3 Volt Intel[®] Advanced+ Boot Block Flash Memory

28F800C3, 28F160C3, 28F320C3, 28F640C3

Specification Update

Order Number: 297938-014

2. 28F320C3xC Reset Failure

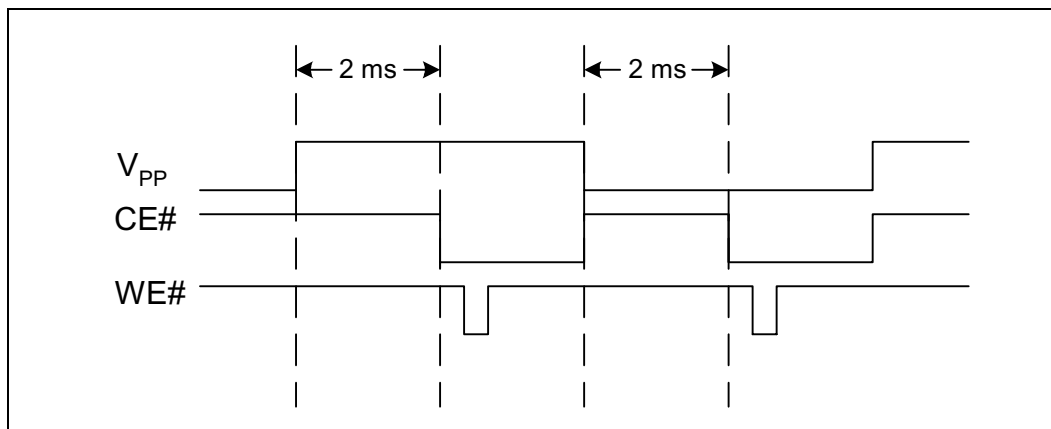
Problem: The 0.18 μm 28F320C3xC devices can unintentionally reset under certain conditions where V_{PP} toggles.

Implication: When the reset occurs, any command being executed is interrupted and the flash switches to read array mode.

- 1) Tie V_{PP} to V_{CC} ;
- 2) If the third and forth digits on the top side FPO mark (third line) is equal or greater than “23”, then V_{CC} may be set from 2.7v to 3.3v. V_{CC} must not exceed 3.3v
- 3) Set V_{PP} to a static high or static low level as shown here; and

4) Wait 2 ms after a V_{PP} transition to access the flash device, as shown here.

Figure 1. Workaround Placement

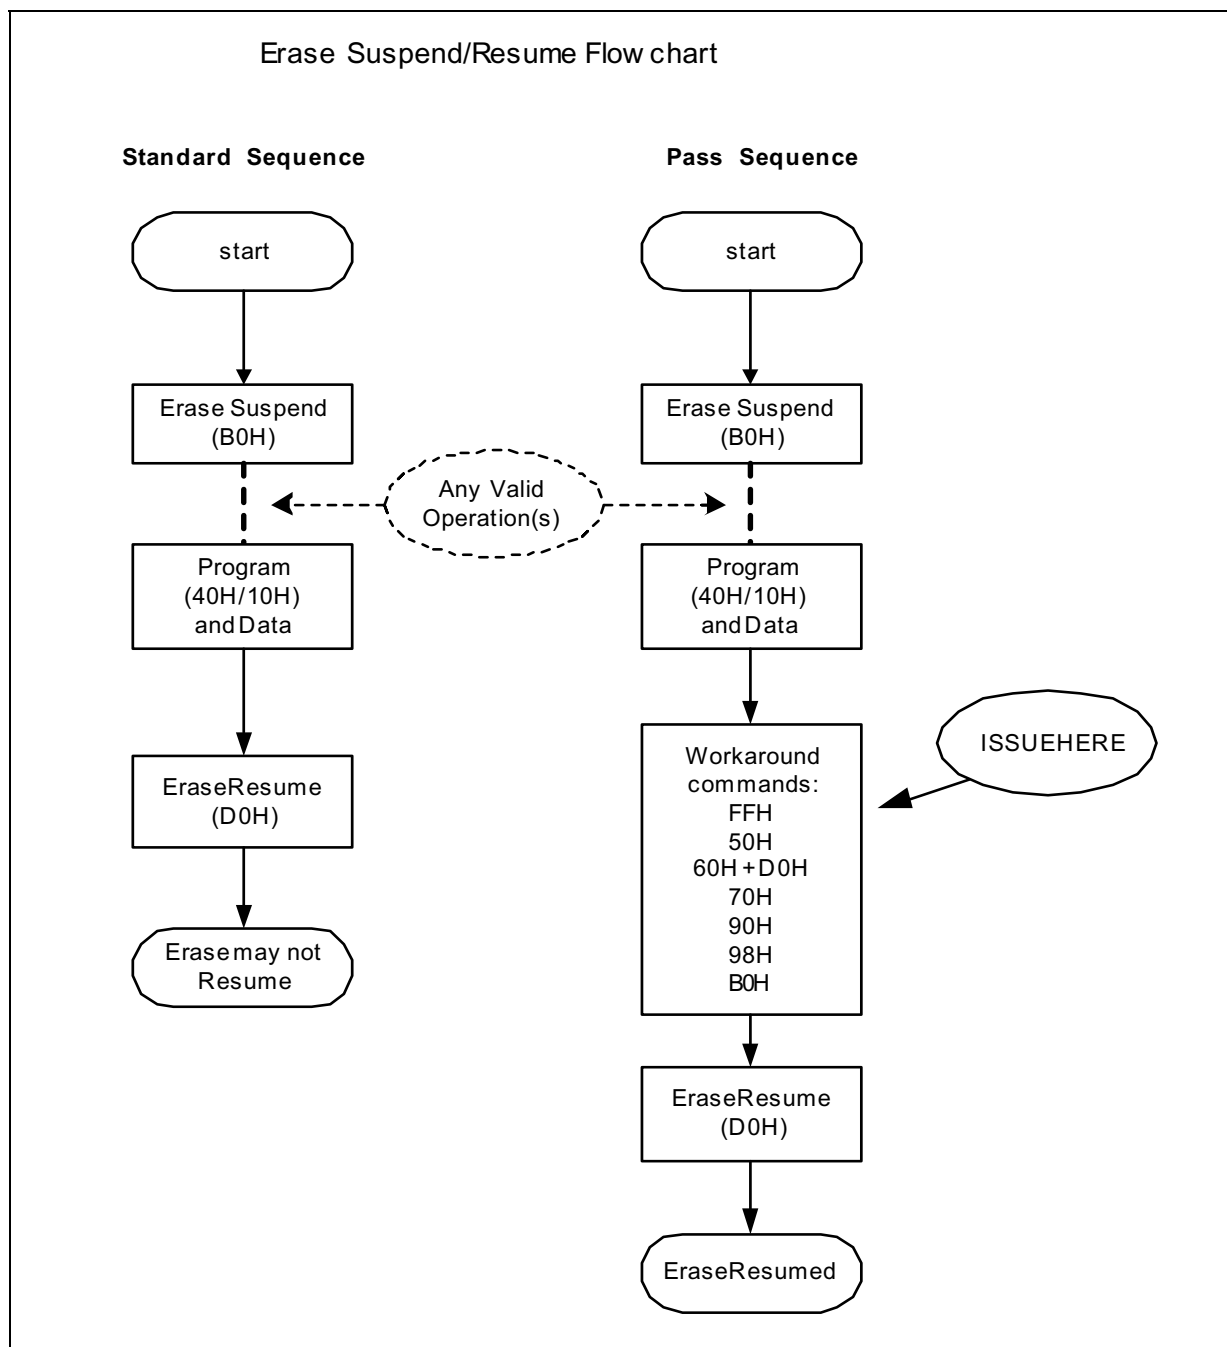
Problem: On the 0.18μm 28F160C3xC devices, a design anomaly was discovered. During an Erase-Suspend operation, if the Program (40H/10H) sequence is executed, under limited conditions the proceeding Erase Resume command (D0H) may not actually resume the device. No customers have reported failures in product applications. Customers who use any version of FDI (Intel Flash Data Integrator) software will not see this issue. If the Read Array command is issued prior to the Erase Resume command, users will not see the issue (typical in XIP applications).

Implication: The Resume Command (D0H) may be ignored by the device and will not correctly resume. The device will appear to remain in suspend (via status register). After a reset of the flash device the status register will clear. This failure has been recreated in a lab environment only.

1. If FDI (Intel Flash Data Integrator) software is used, users will not see the issue.
2. During an Erase-Suspend (B0H), user must issue any of the following commands after issuing the Program (40H/10H) and data sequence but before issuing the Erase-Resume (D0H) command.

5. 28F160C3xC and 28F640C3xC Lock/Unlock/Lock-Down Operation

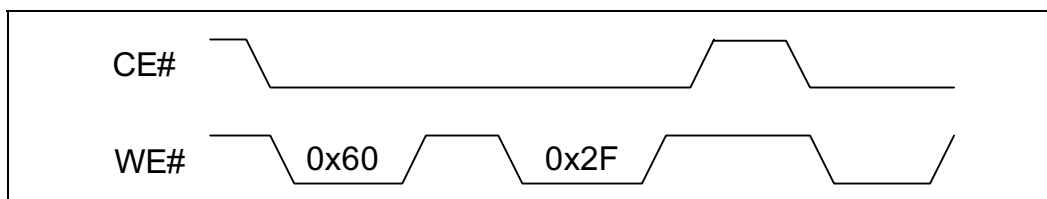
Problem: On the 16Mb and 64Mb 0.18µm devices, if CE# is deasserted after any block lock operation and before the next write sequence, the part may perform the same operation on additional blocks. (See waveform below.)

Implication: When CE# is deasserted after performing a block lock operation to a specific block and prior to the next write sequence, other blocks may perform the same operation.

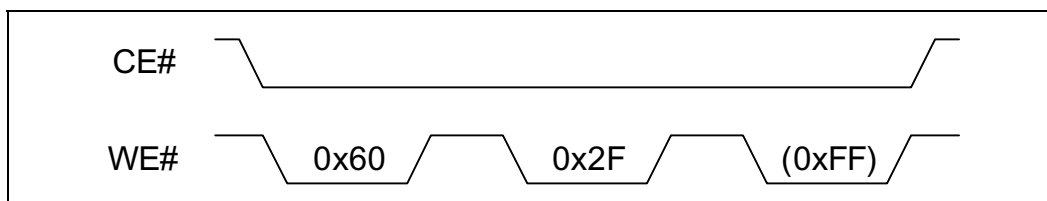
Workaround: Depending on software implementation, systems may already be effectively managing this erratum. There is currently a workaround for this erratum:

Immediately after performing a block lock, unlock, or lock-down operation, perform a valid write sequence before chip enable (CE#) is deasserted.

- 1) Assert CE# and toggle WE# to write the block lock setup command (0x60).
- 2) Toggle WE# a second time to write the confirm command (lock = 0x01; unlock = 0xD0; lock-down = 0x2F).
- 3) Toggle WE# a third time (ex: 0xFF- Read Array) before CE# is deasserted. (See waveform below.) Any other valid write sequence will also work (i.e., 0x90 - Read Configuration, 0x40 - Program, 0x20 - Erase).
